ADDENDUM #1
RFP NUMBER: 2014015-PU-P
North River Pump Station VFD & Electrical Gear RFP
PROJECT 473-12-13
CONTRACT 2

DATE: December 20, 2013

City of Harrisonburg's North River Pump Station VFD & Electrical Gear RFP (2014015-PU-P), is modified as follows:

PUMP STATION INTERIOR PLAN

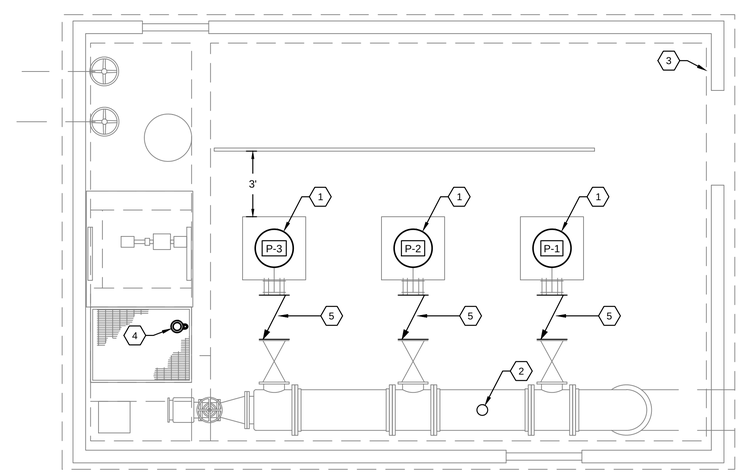
Q2: There is also the requirements of a water cooled bearing with supply from city water system. We also did not see this on the photos they provided.
R2: Bearing oil will be circulated through a heat exchanger cooled by City water supply, refer to proposed installation drawings attached.

(3) INSTALL NEW 3/4-INCH COPPER WATER SERVICE, PROVIDE 3/4-INCH HOSE BIB AND VACUUM BREAKER; PROVIDE DISTRIBUTION PIPING AND ISOLATION VALVES TO EACH WATER COOLED HEAT EXCHANGER AT MAIN PUMPS
